APPLICATION NO.	FILING DATE	FIRST NAMED INVENTOR	ATTORNEY DOCKET NO.	CONFIRMATION NO.
09/788,420	02/21/2001	Oh Nam Kwon	8733.388.00	5851

Office Action Summary	Application N . 09/788,420	Applicant(s) KWON ET AL.	
	Examin r George Y. Wang	Art Unit 2871

DETAILED ACTION

FIG. 8

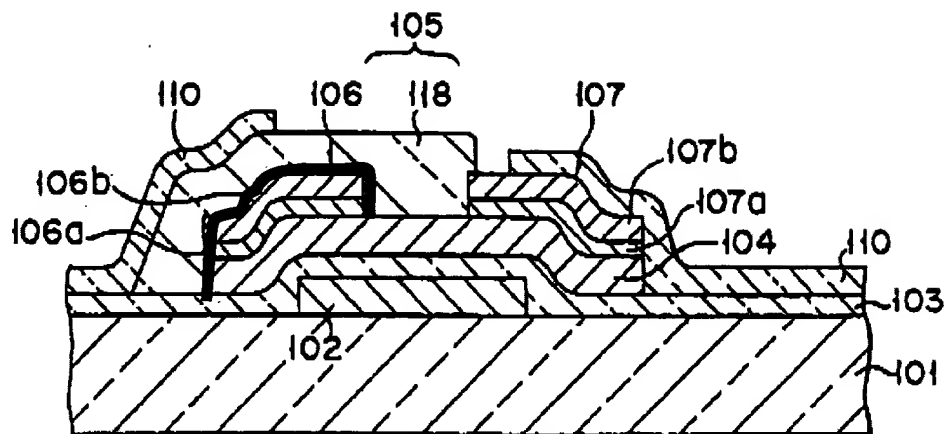
Applicant's first argument is that the second insulating layer of the Wakai reference does not teach "a contact hole exposing a portion of the third conductive layer." However, Examiner asserts that the Wakai reference clearly teaches this in Fig.

8. See bolded area below.

FIG. 8

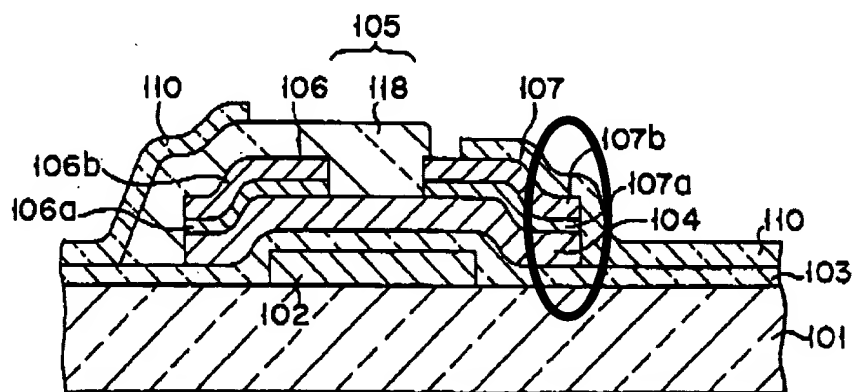
Applicant's second argument is that the Wakai reference does not disclose a fourth conductive layer on the second insulating layer and electrically contacting the third conductive layer. Examiner asserts that the Wakai reference does teach this in Fig. 8. See circled area below.

Accordingly, Applicant's arguments are not persuasive. The Wakai reference clearly teaches all the claimed limitations. Therefore, Examiner, holds to the validity of the Wakai reference and maintains rejection.
